PLANNING REPORT

MINISTERIAL REFERRAL

The subject land is located on the corner of Queen and Therry Streets, directly adjacent to the Queen Victoria Market (QVM).

The City of Melbourne has been referred two applications for comment by DELWP in regard to the QVM Munro development.

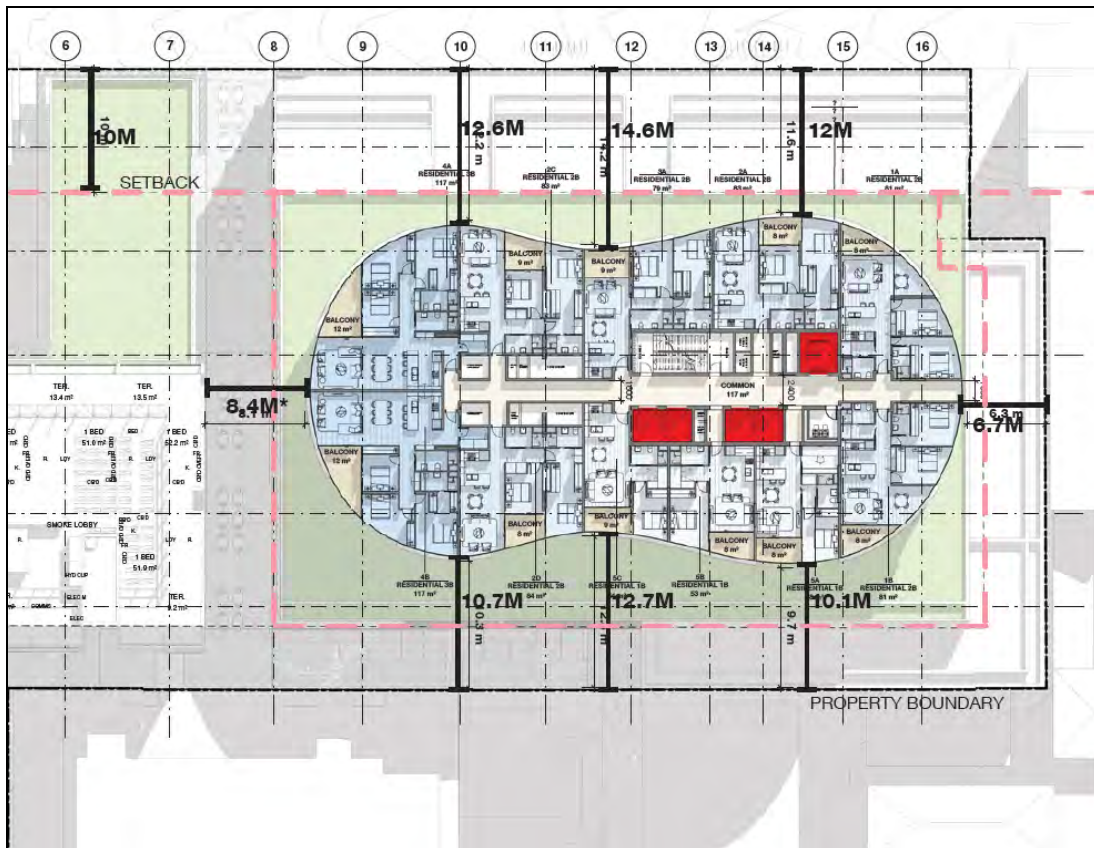
We support the rhythmic design of the canopy which reinforces the grain of shop fronts. However, the canopy rises at the eastern end of the frontage due to the slope, reducing the enclosure of the public realm. The canopy should step to the east of the arcade location to respond to the slope and the low-rise eastern neighbour as well as to provide effective weather protection.

In response to these matters the applicant has responded, advising that while the internal planning of the hotel requires a consistent floor level along the extent of the northern façade, that the suggestions of varied canopy and parapet heights along the street can be met with further study and design resolution and this can readily be addressed in a condition of any permit to issue.

Munro West – Level 2 plan

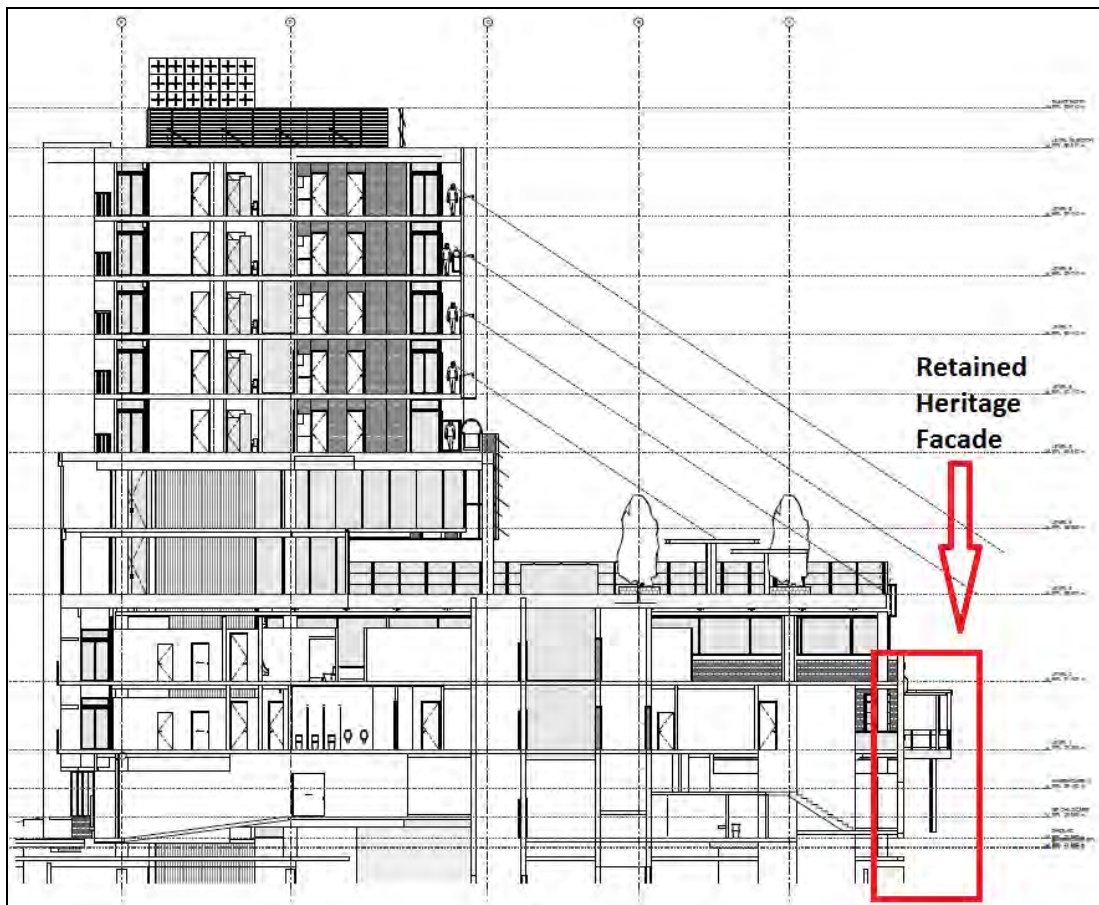
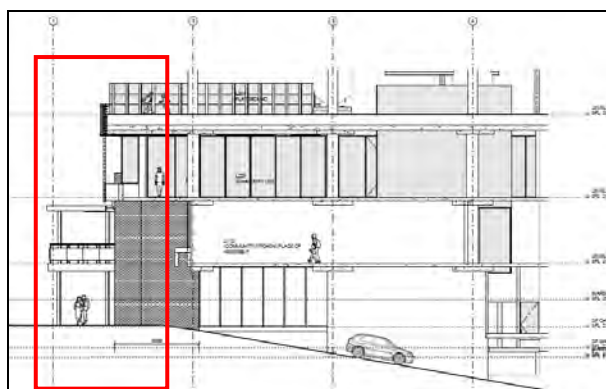
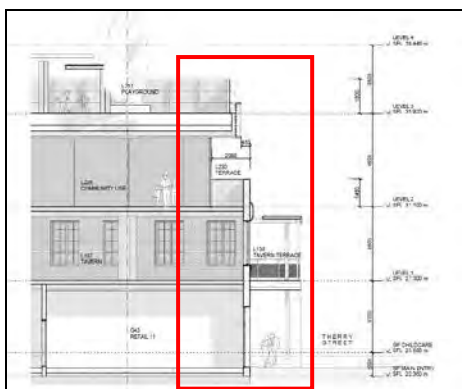
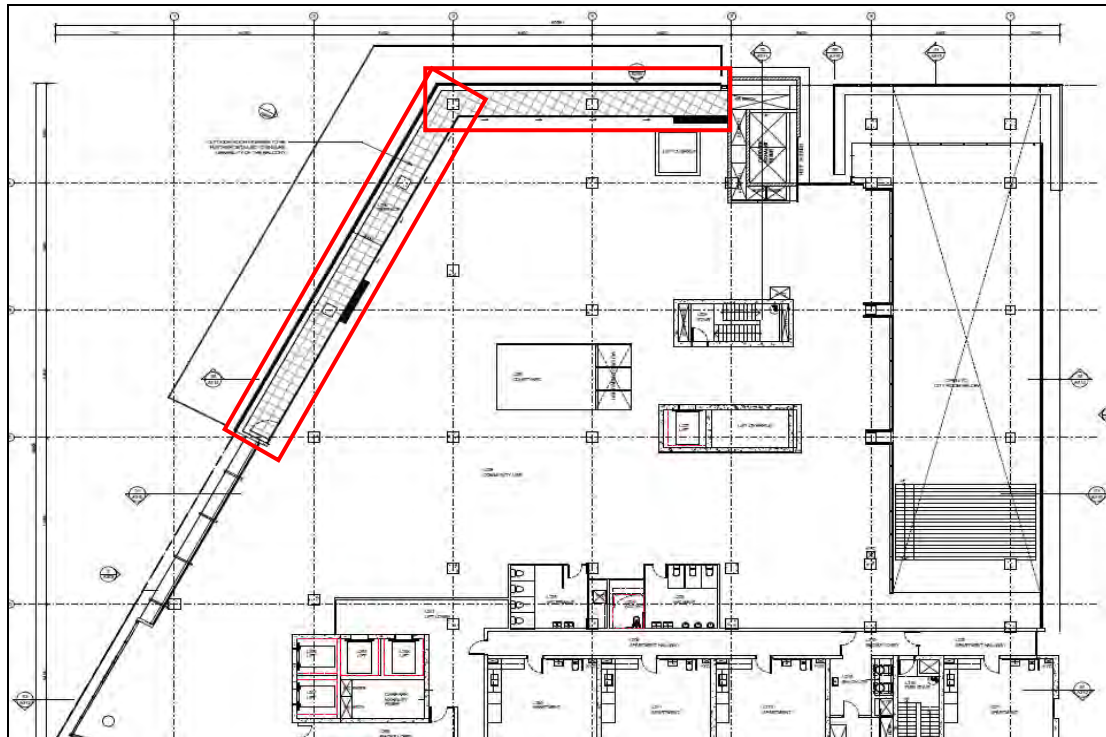
The City of Melbourne’s Heritage Advisor has suggested that a setback to levels two and three of 5 metres from both streets with a potential terrace incorporated within the setback zone at level two would be an appropriate response in ensuring the heritage building is appropriately expressed.

In response to the concerns the applicant provided the following commentary:

metre setback on level 2 with cantilevered open space above is considered appropriate. A reduction in floor area for the Child Care use would result in a reduction in available child care placement numbers under relevant legislation.
